WEST OF IFIELD PHASE 1A

Stage 1 Road Safety Audit

10051123-ARC-XXX-1A-TR-HE-00001

NOVEMBER 2024

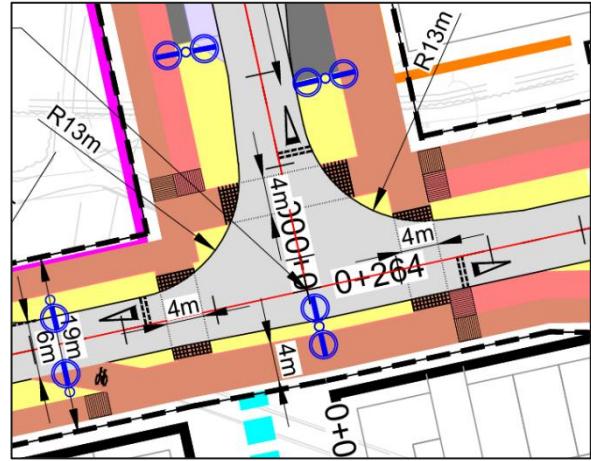
Location: B – RD_1A_S01 near Entry treatment JC_1A_S01, West of Ifield Phase 1A (Drg. 10051123_ARC-050-1A-DR-CE-00001 Rev P04).

Summary: Risk of slip hazards for exiting motorists.

There is a risk that cyclists and powered-two-wheelers exiting the RD_1A_S02 side road may ride across the path of manhole cover MH-40 whilst turning and become unseated (see insert). This may lead to leading to secondary collisions (see insert).

A similar situation occurs at the following locations (ref. Drg. 10051123_ARC-070-1A-DR-CE-00004 Rev P06):

- MH-10 near the foul pumping station
- MH-4 (opposite above pumping station)

Ensure the manhole cover does not pose a slip / skid risk to riders.

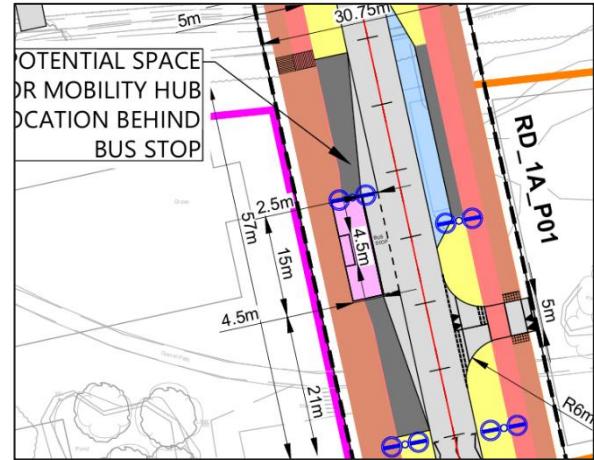
Location: General – Rear of bus stops along RD_1A_P01 & RD_1A_P02 West of Ifield Phase 1A (Drg. 10051123_ARC-050-1A-DR-CE-00004 Rev P06 & 10051123_ARC-050-1A-DR-CE-00007 Rev P06).

Summary: Access to and from bus shelters may conflict with cyclists

There does not appear to be any designated or prioritised route generally for users walking to or from the proposed bus shelters (see insert).

Given that passenger numbers alighting can notably be high, with some users distracted, looking the wrong way, impaired, or unaware of approaching cyclists, there is a risk that pedestrians may proceed towards the footpath heedless of approaching cyclists.

In addition, the space behind some bus shelters becomes narrow and creates a potential pinch point for pedestrians and cyclists alike, and this is likely to exacerbate conflicts further.

Establish a safe route to the bus stop shelters and encourage courtesy from approaching cyclists. This may consist of additional formal or informal measures to calm approach speeds and manage the shared space more effectively.

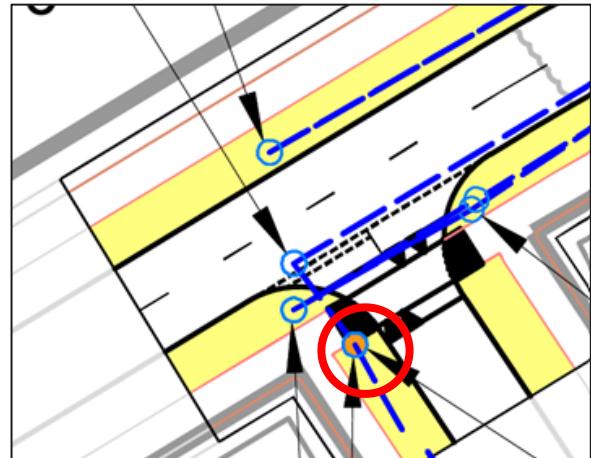
Location: B – RD_1A_S02 Entry treatment crossing facility, West of Ifield Phase 1A (Drg. 10051123_ARC-050-1A-DR-CE-00001 Rev P04).

Summary: Risk of slip / trip hazards associated with manhole cover.

The position of manhole cover MH-39 appears to be located at or near the southern side road uncontrolled crossing RD_1A_S02 tactile paving (see insert). This may present a slip / trip hazard to those using the uncontrolled crossing facility particularly if the manhole cover is uneven, incorporates an upstand or is slippery underfoot.

A similar situation occurs at the following locations:

- MH-73 RD_1A_P01
- MH-30 RD_1A_P01
- MH-53 RD_1A_P02
- MH-87 RD_1A_P02
- MH-143 RD_1A_P02

Ensure manhole covers does not pose a risk to walkers or cyclists.

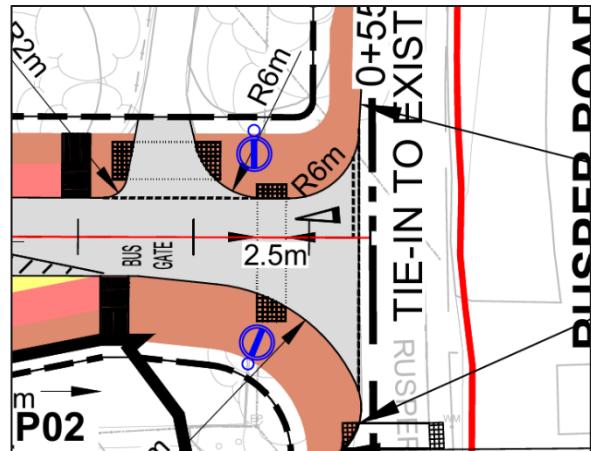
Location: E – RD_1A_P02 / Rusper Road crossing facility, West of Ifield Phase 1A (Drg. 10051123_ARC-050-1A-DR-CE-00009 Rev P06).

Summary: Risk of crossing collisions.

Walkers crossing at the junction are expected to cross the carriageway in one go or risk being stranded in the middle of the road where they may be struck by turning traffic.

This may be a particular problem for those frail, mobility / sensory impaired crossing the wide carriageway, looking in multiple directions and avoiding large turning vehicles such as buses.

The use of a refuge island at the junction bellmouth may allow crossing walkers to cross safely in two halves, whilst providing a safe space to wait and observe oncoming traffic.

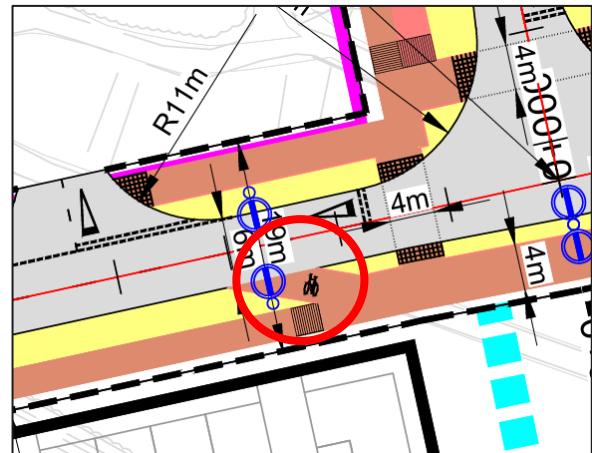
Location: F – RD_1A_S01 opposite RD_1A_P01 Southern shared use facility, West of Ifield Phase 1A (Drg. 10051123_ARC-050-1A-DR-CE-00007 Rev P06).

Summary: Risk of cycle collisions.

Cyclists are required to exit the share use facility and rejoin the carriageway with their backs to oncoming westbound traffic (see insert). If cyclists continue to enter the road heedless of oncoming traffic, this may lead to side-swipe collisions.

Ensure cyclists entering the carriageway to join traffic have a clear sight of oncoming traffic, or be expected to yield accordingly.

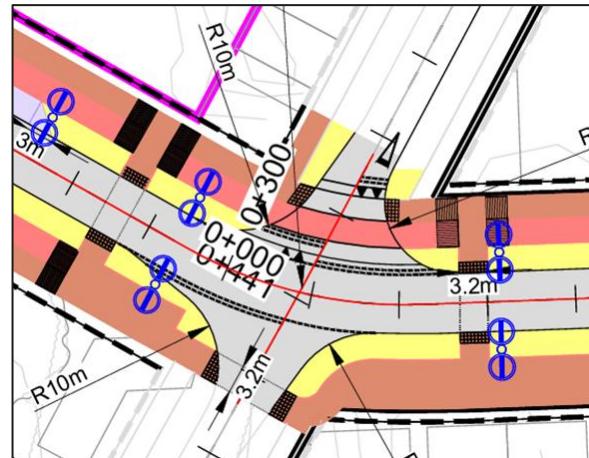
Location: G – JC_1A_S06 Junction crossing facilities, West of Ifield Phase 1A (Drg. 10051123_ARC-070-1A-DR-CE-00007 Rev P06).

Summary: Risk of walker collisions.

Poorly located crossing facilities either side of the junction may lead to collisions with walkers (see insert). There is a risk that motorists approaching the junction may be preoccupied by turning manoeuvres or focus on emerging traffic, rather than concentrating on crossing activities.

Provide suitable refuge islands at the junction to enable walkers to cross one stream of traffic at a time.

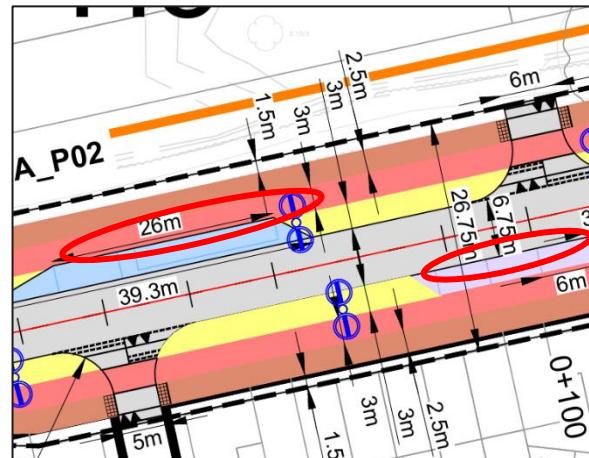
Location: H & I – RD_1A_P02, West of Ifield Phase 1A (Drg. 10051123_ARC-070-1A-DR-CE-00007 Rev P06).

Summary: Risk of cyclists being struck by car doors.

Parking and loading bays positioned immediately adjacent to cycleways may put cyclists at risk of collisions when vehicle doors are opened directly into the path of approaching cyclists.

A similar situations occurs along multiple locations eastwards along RD_1A_P02.

Provide a suitable 'buffer zone' between cyclists and parked vehicles to mitigate the risk of vehicle doors opening onto oncoming cyclists.
